CITY OF CROSSLAKE

PLANNING COMMISSION/BOARD OF ADJUSTMENT

Applicant: Robert W & Barbara J Eng

STAFF REPORT

CERTIFICATE OF SURVEY

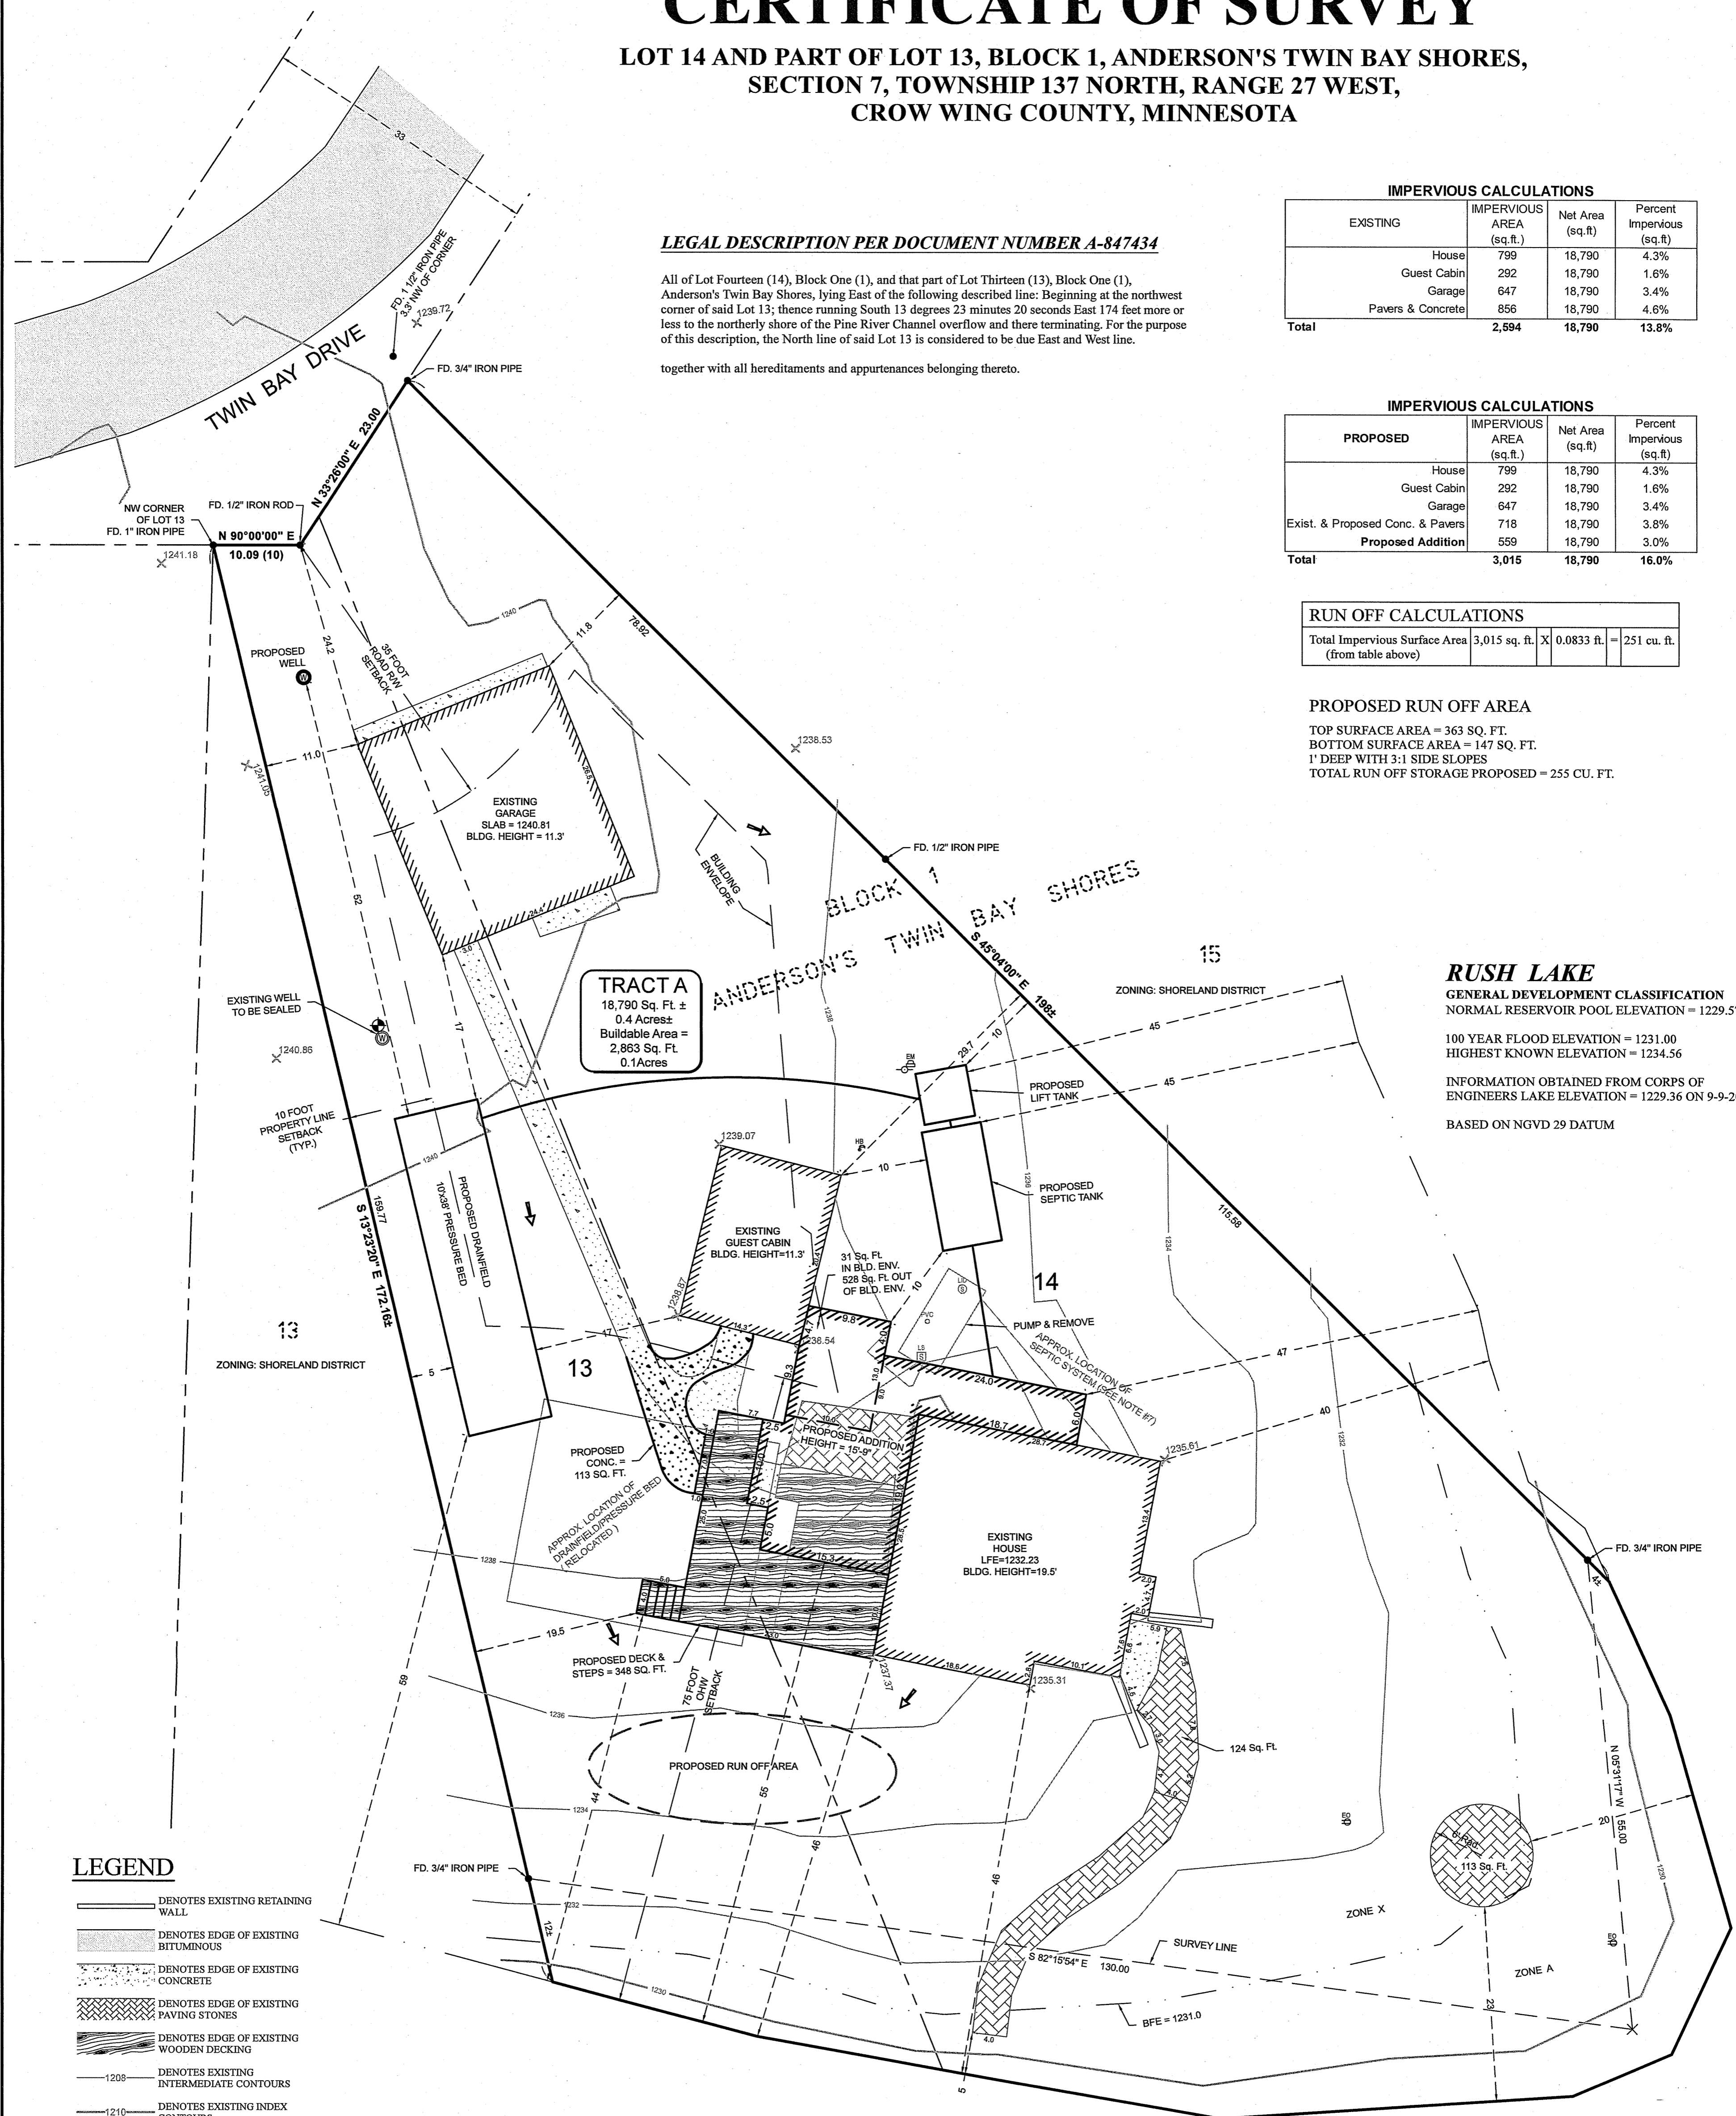
- Property is located on Rush Lake at 37241 Twin Bay Drive with a lake setback of 75 feet
- The proposed additions to be 46' from the OHW
- Additions to the west and north to include, deck, main level, lower level and connection to the existing auxiliary cottage-no proposed change to existing structures per discussion
- Elevation for Rush Lake of 1232.5 to be met – a condition may be placed for a supplemental form
- All setbacks shall be measured to the vertical side of the structure. No part of the structure, such as eaves, can overhang or reduce such setback by more than three feet (Sec. 26-308).
- Setbacks on structures where the eaves exceed 36" shall be measured from the drip line.

- Impervious maximum of 25% and if impervious exceeds 20% a Shoreline Rapid Assessment Model form will be completed; discussion best guess at 17% after proposal

- Design and implement a stormwater management plan (gutters, berm & rain gardens) to update any existing plan, which is required with all variance applications for the entire parcel per Article 8, section 26-222, (2), 1). When wetland is being used it must be filtered to drinking standards before it can flow into any wetland

- A compliant septic compliance inspection is on file dated 5-25-16
- An application will need a septic design submitted to Crow Wing County for approval

- Wetland Delineation is a requirement for a variance or a no wetland statement/letter
- A grade and elevation illustration along with a cut and fill calculation is required-possible spoils may need to be removed from the site
